JUNCTION CITY LAND USE FINDINGS FOR A TYPE-I DEVELOPMENT REVIEW

File Number: DEV-22-26, 135 E 1st

Summary of Findings: Development Review conditional approval is granted to allow construction of a 37,800 square foot industrial building located to the west of an existing building #5 on property zoned Light Industrial (M1).

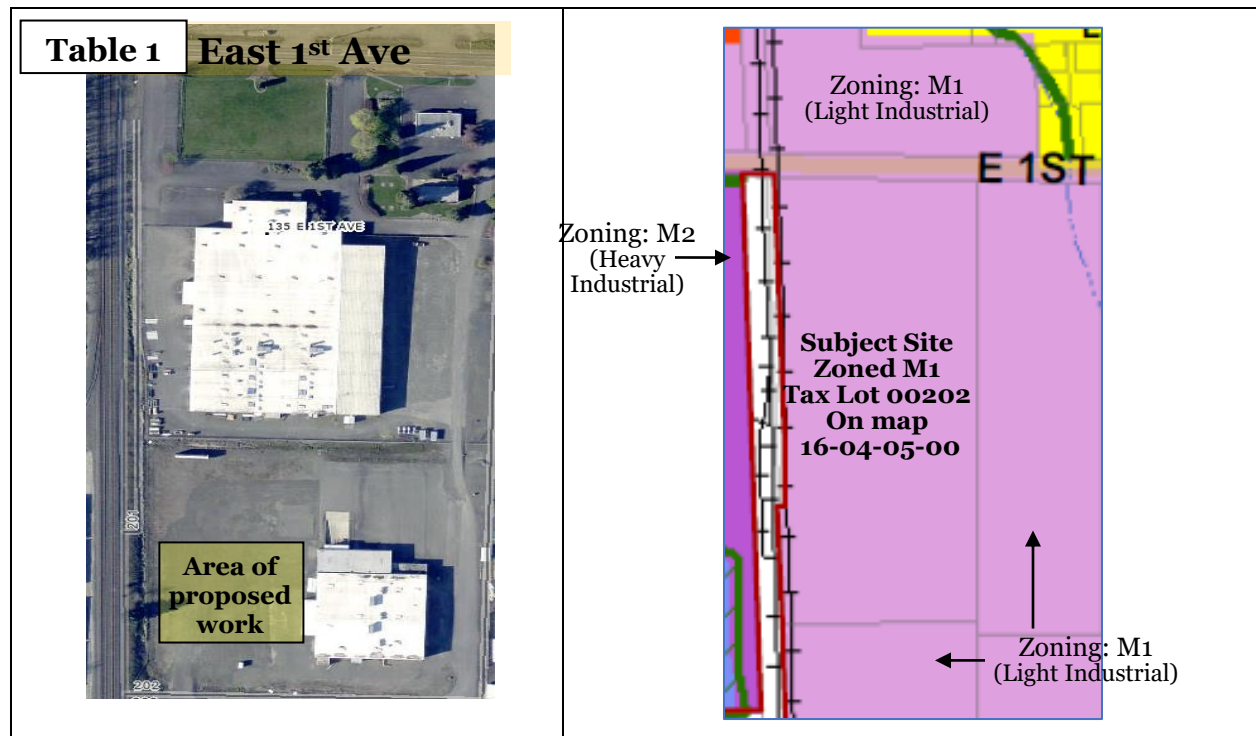
3. Per JC PWDS section 3.10.d.1, “Pre-development shall be defined as a site with natural vegetation on native soil.” Therefore, when comparing peak runoff rates for pre- and post-development where development is proposed, the pre-developed condition shall be natural vegetation on native soil (regardless of the current condition) and the post developed condition is based on the proposed surface.

4. Per JC PWDS section 3.18.d.5.c, "The side slopes for detention basins shall be no steeper than 4H:1V. Steeper slopes may be used where approved in writing by the City Engineer and Public Works and if access to the detention facility is restricted by chain link or other approved fencing a minimum of six (6) feet high." The proposed infiltration basins appear to have slopes as steep as 1:1, which does not meet this design standard.
